SUBJECT: Pamlico County; NC 55 from SR 1127 (Bayleaf Road) to East of
SR 1129 (Bennett-Tingle Road); State Project No. 8.1170901;
T.I.P. # R-2539B

**Widening of NC 55
From SR 1127 (Bayleaf Road) to
East of SR 1129 (Bennett-Tingle Road)
in Pamlico County
Federal Aid Project No. STP-55(1)
State Project No. 8.1170901**

SUBJECT: R-2539B revised permit drawings and summary, sheets 19 and 39 of 40

SITE 1 -L- STA. 56+30 TO 56+55 LT

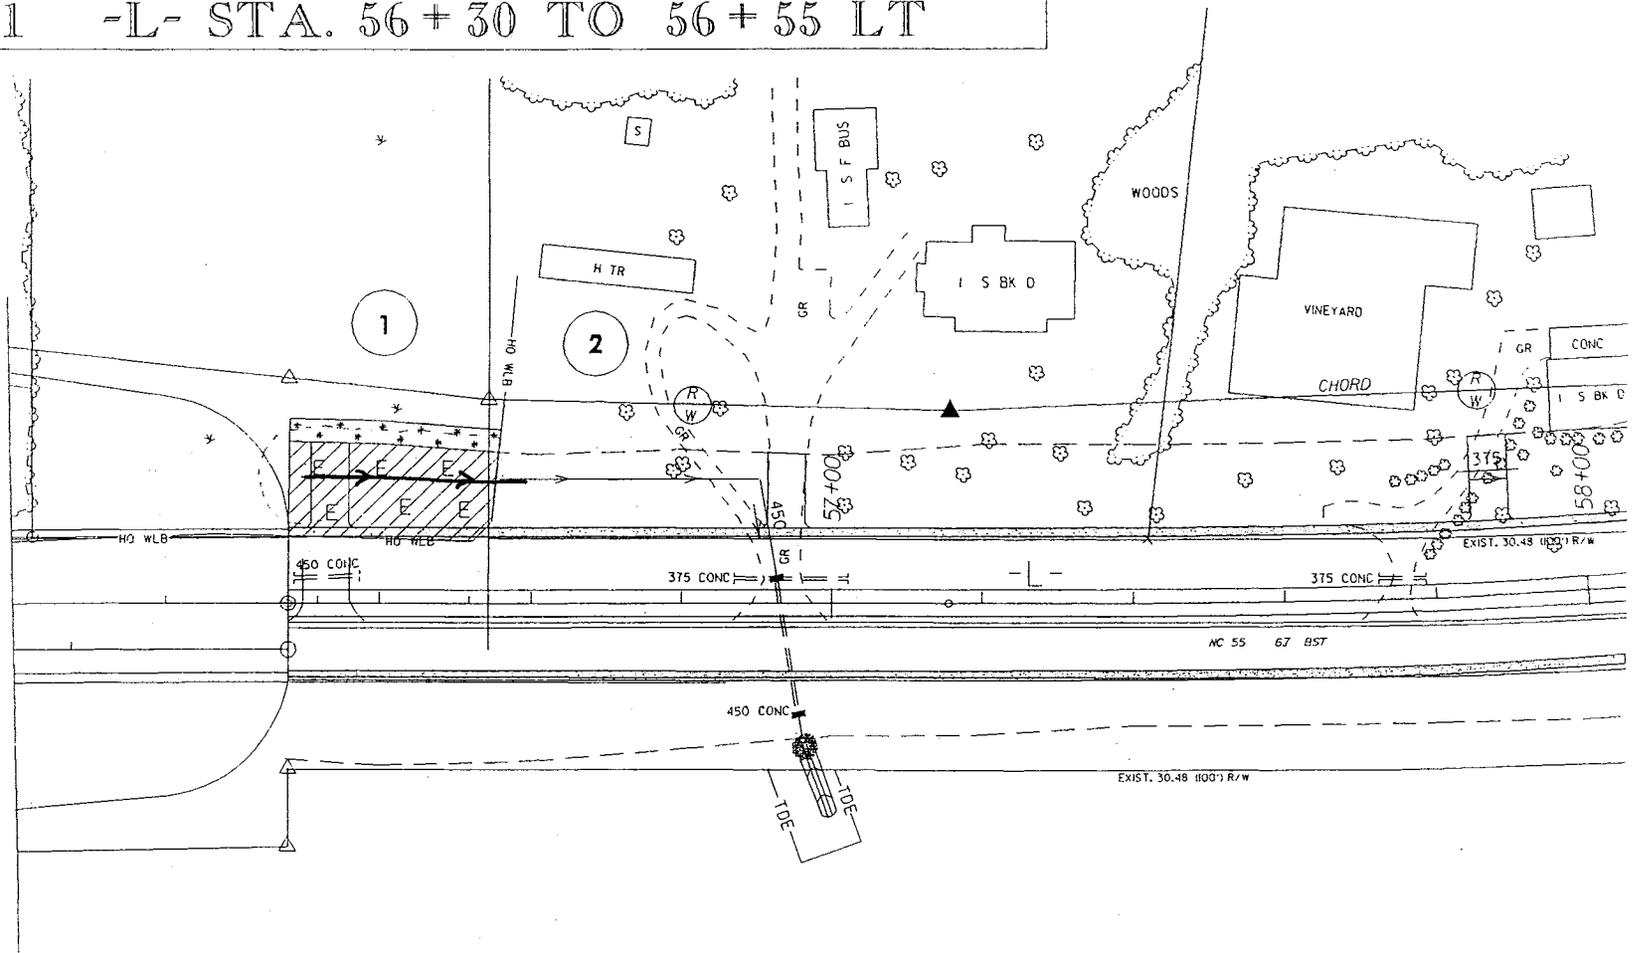
Site 1, Permit Sheet 7 of 40. Because of low grade and minimal drainage potential of the natural ground elevation at this site, NCDOT proposes to install a V-ditch with 6:1 side slopes to drain the subgrade of the new road. The new ditch will drain 0.06 acres of non-riverine wetlands.

Site 1, Permit Sheet 7 of 40

Impact change: increase of 0.06 acres of non-riverine wetland impacts

SITE 4 -L- STA. 74+85 TO 77+40 RT & LT

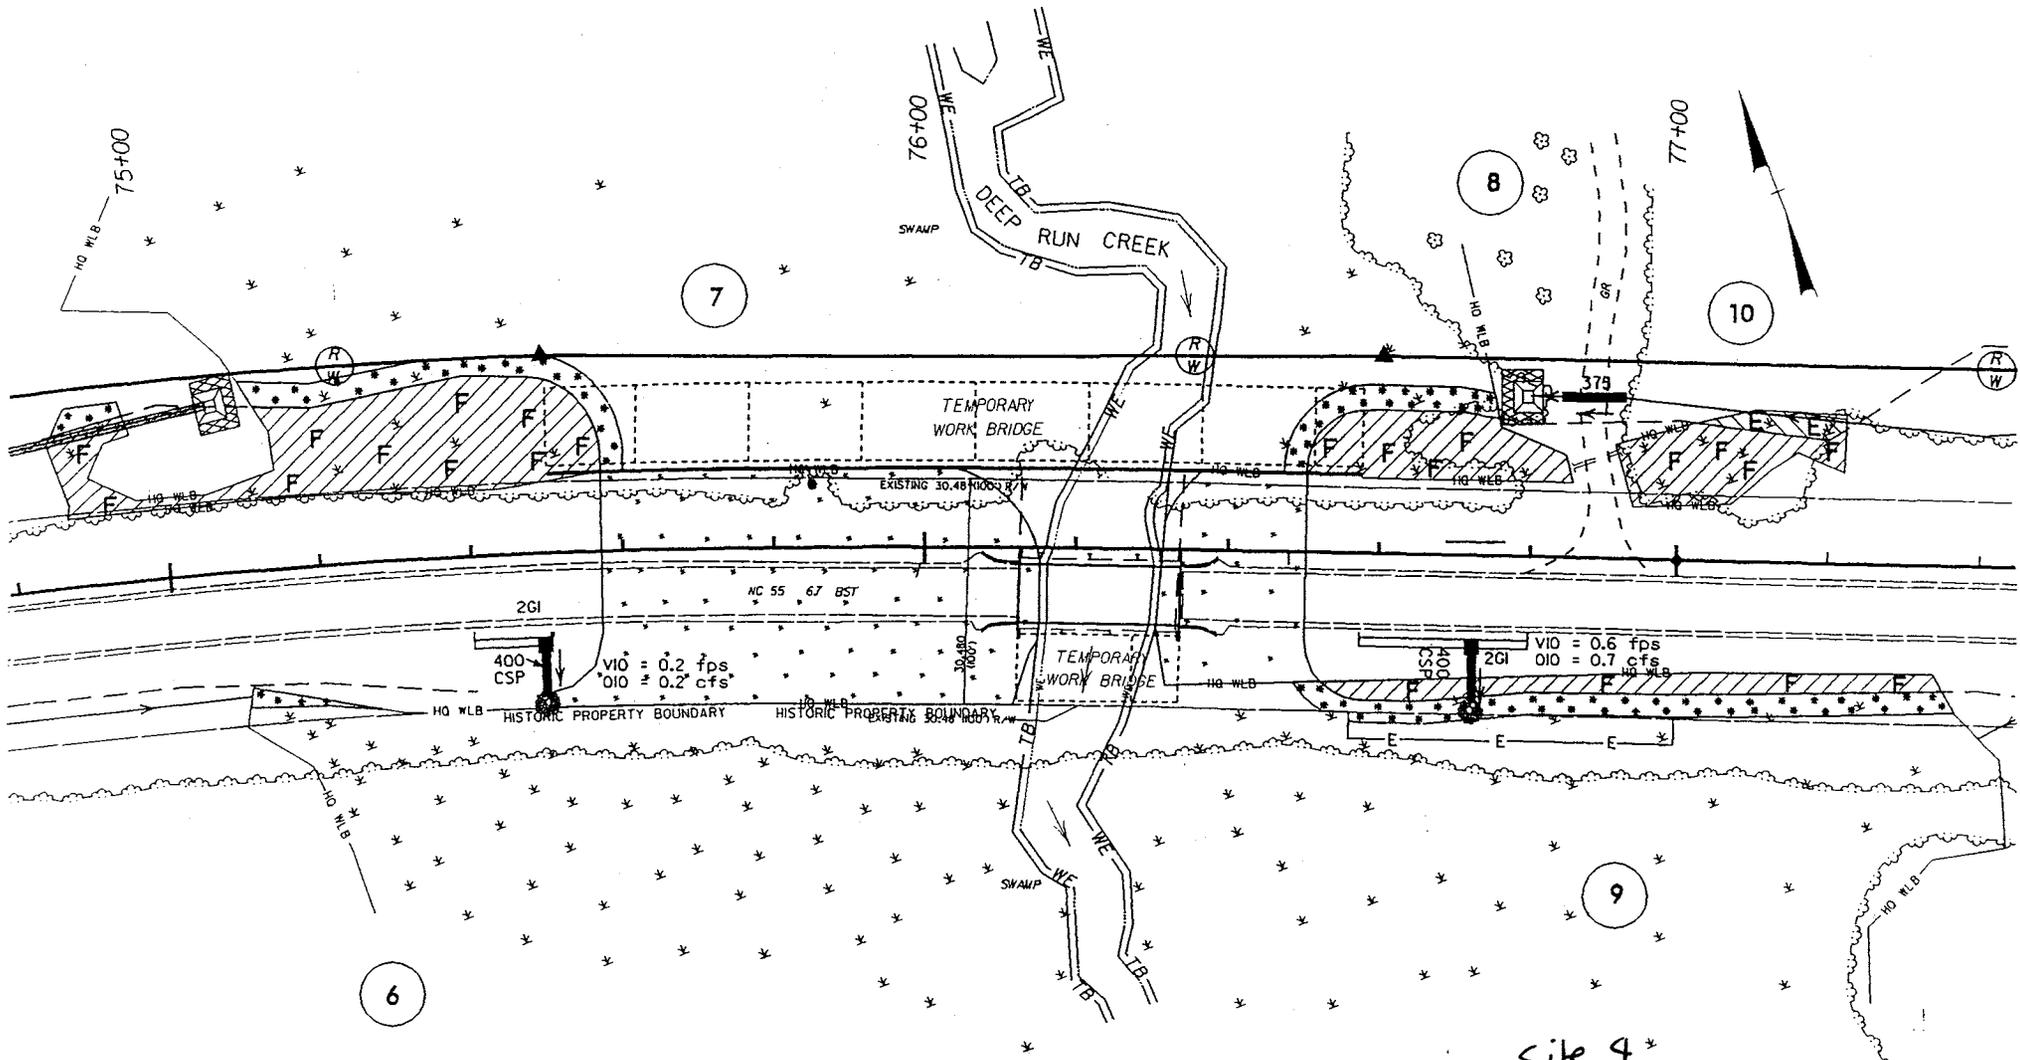
Site 4, Permit Sheet 10 of 40. At this site an area of mechanized clearing in wetlands has been changed to excavation to accommodate a drainage swale.

N.C. DEPT. OF TRANSPORTATION
DIVISION OF HIGHWAYS
PAMLICO COUNTY
PROJECT 8.II70901 (R-2539B)
NC 55 FROM EAST OF SR 1127 TO EAST OF
SR 1129
SHEET 19 OF 40
Revised 10/21/2003

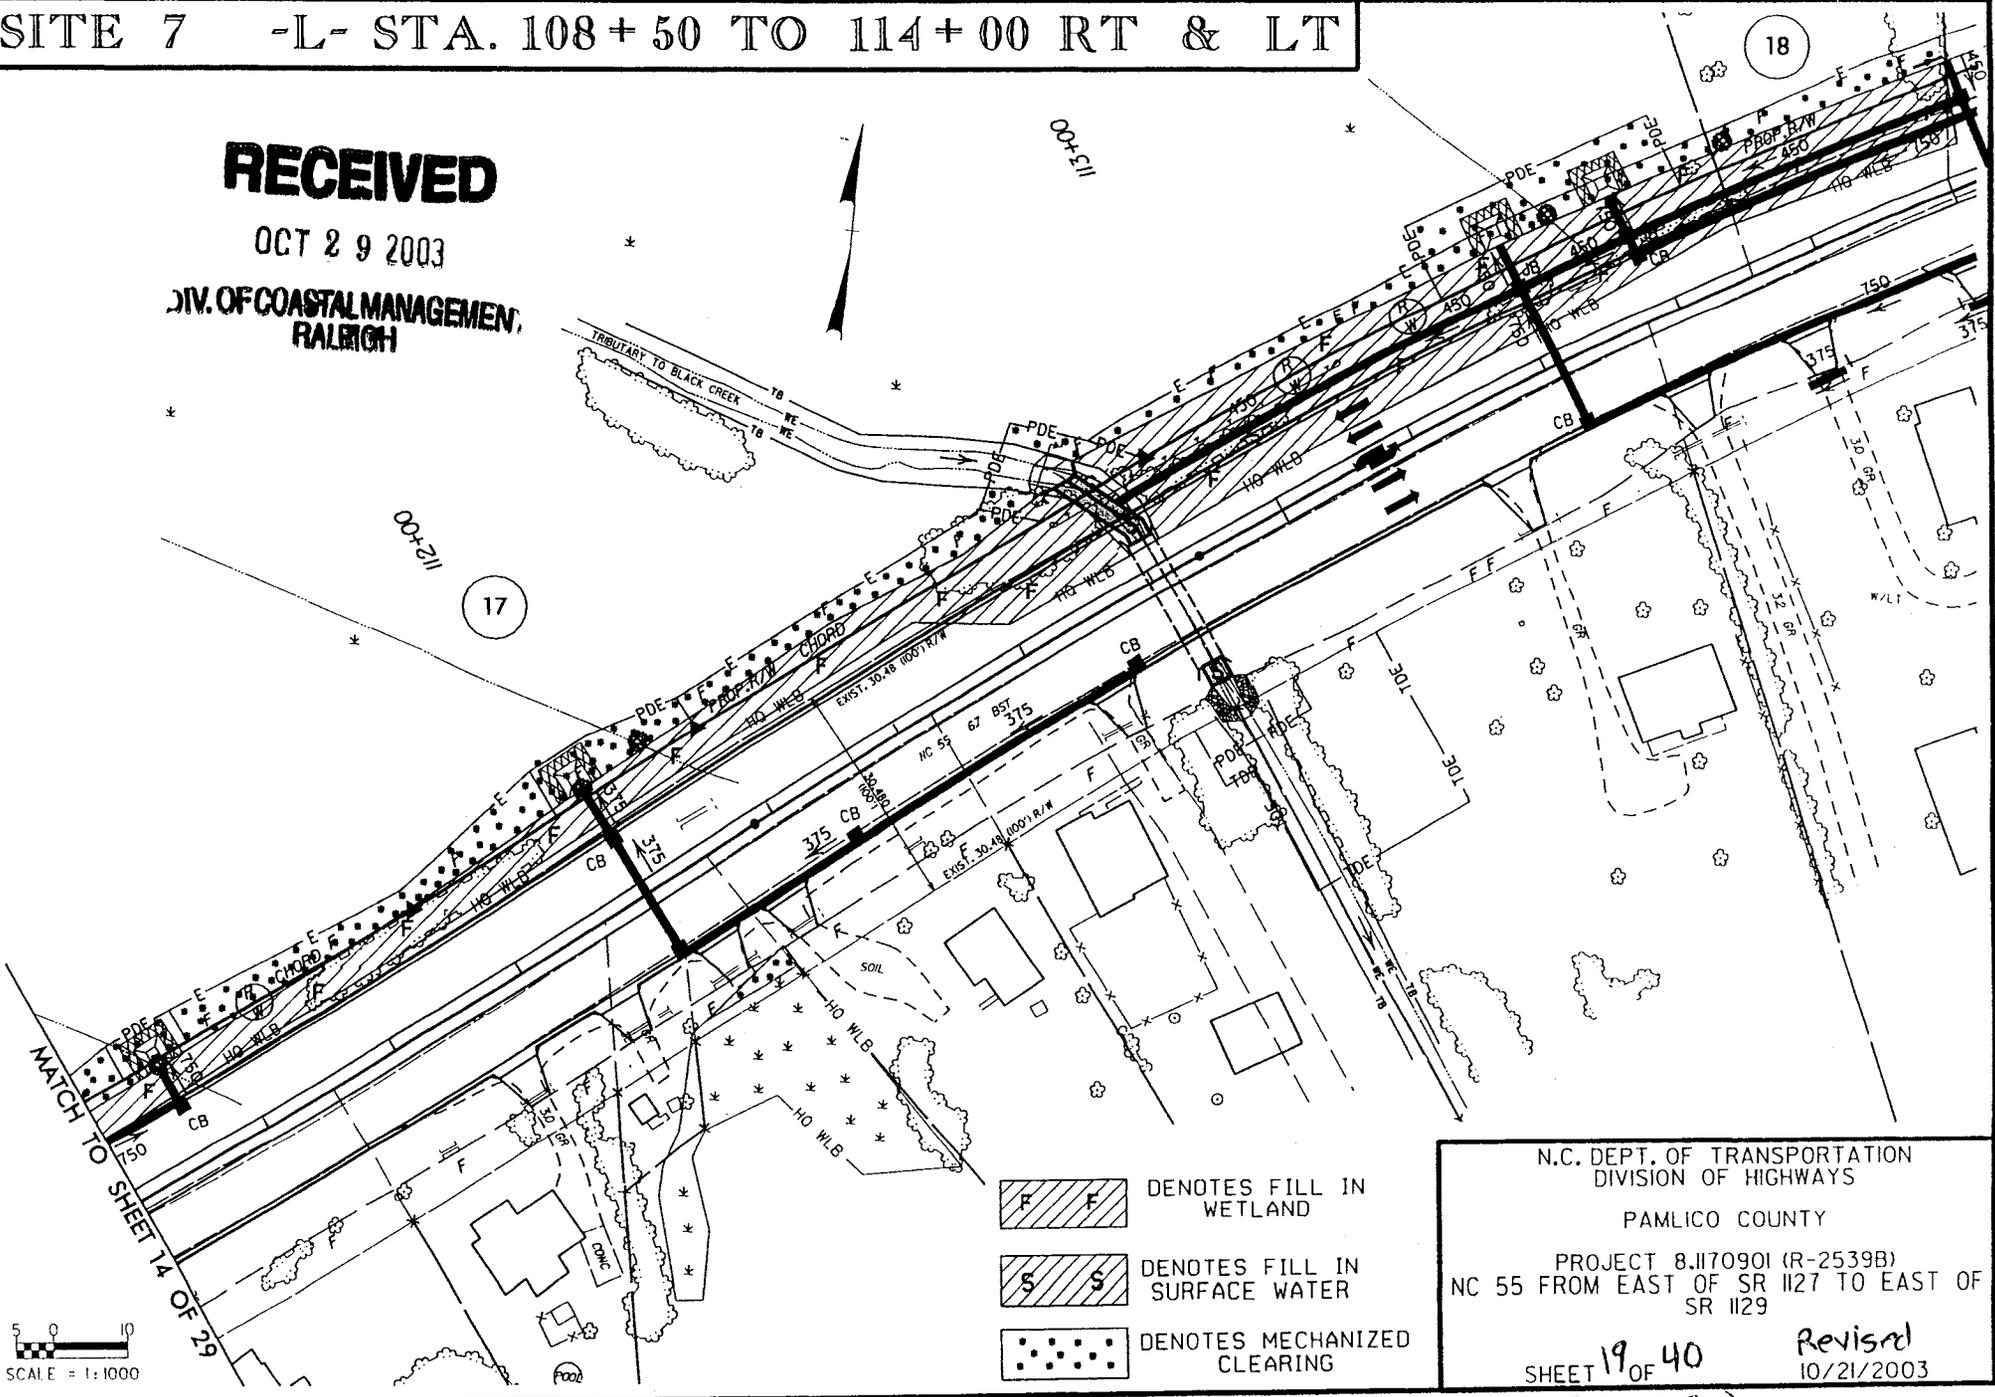
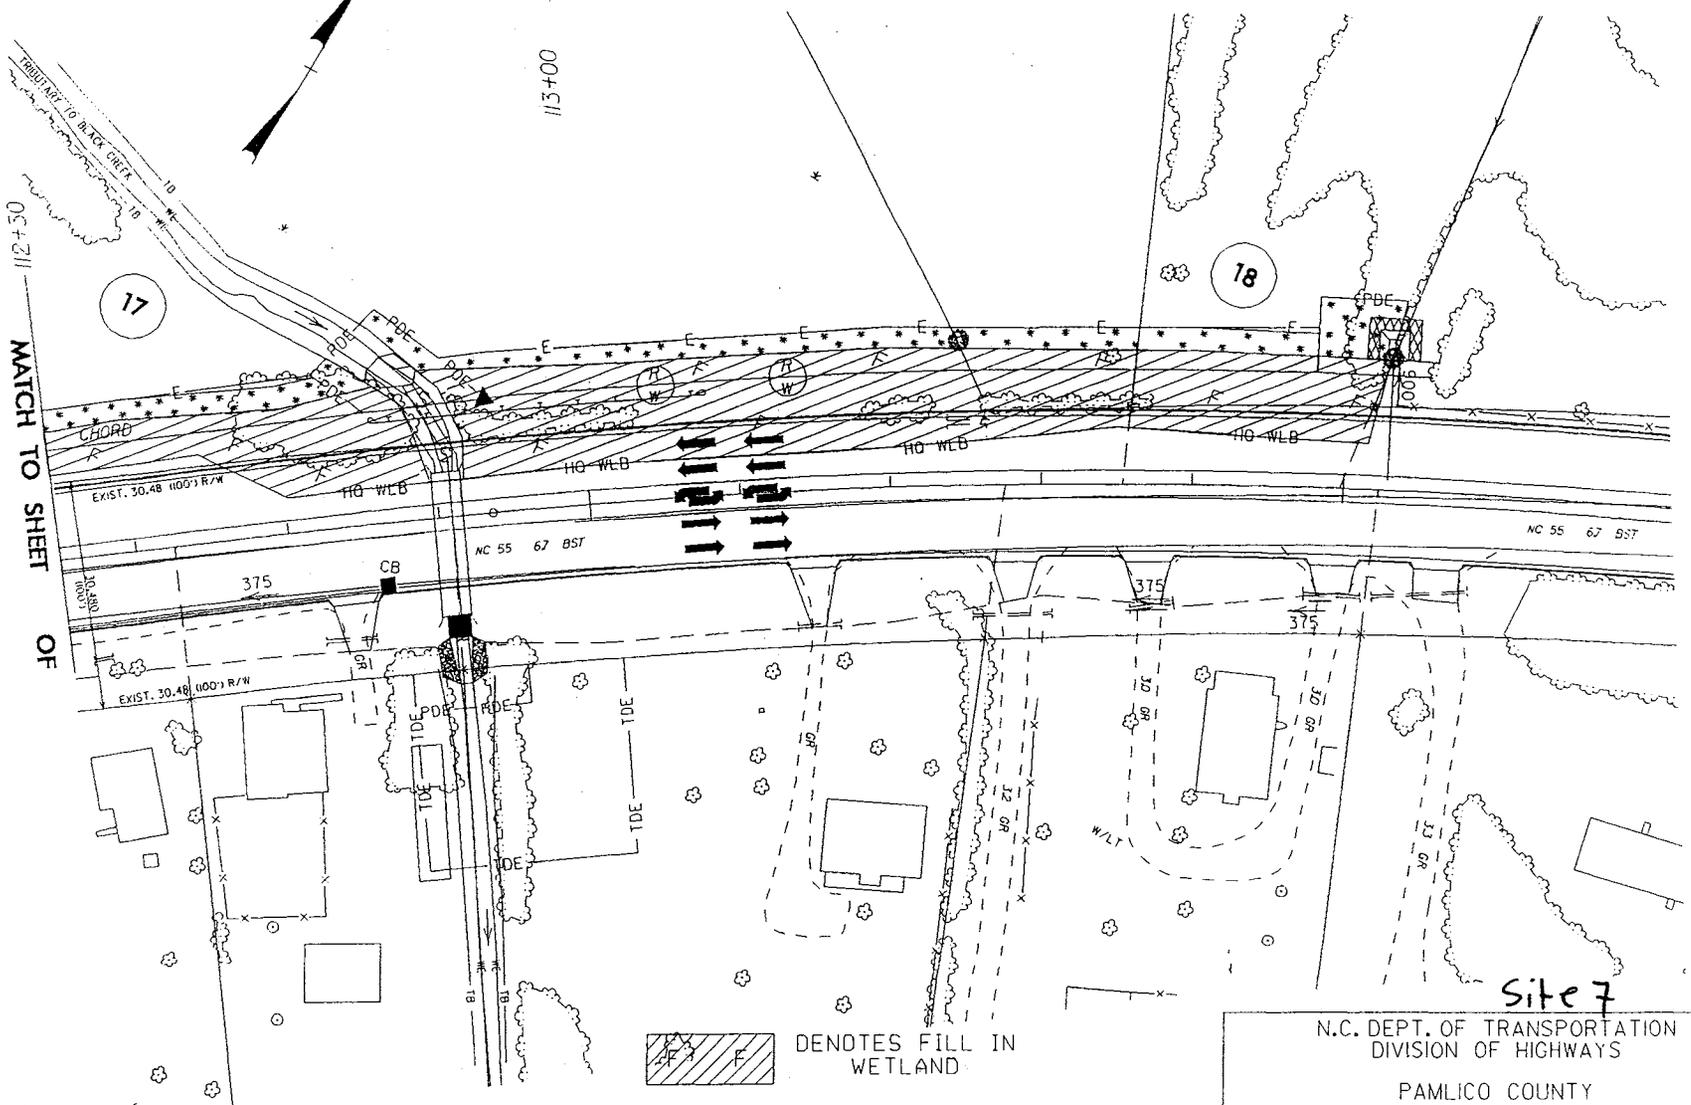
Please find attached revised permit drawing sheets. These revisions were required in order to prevent hydrologic trespass for a property owner north of NC 55 (property number 18). Two new pre-formed scour holes have been installed to receive additional drainage. Mechanized clearing impacts have increased slightly from 0.44 acres to 0.52 acres. Additional mechanized clearing is required around the two newly placed pre-formed scour holes on the north side at Station No. 113+50.
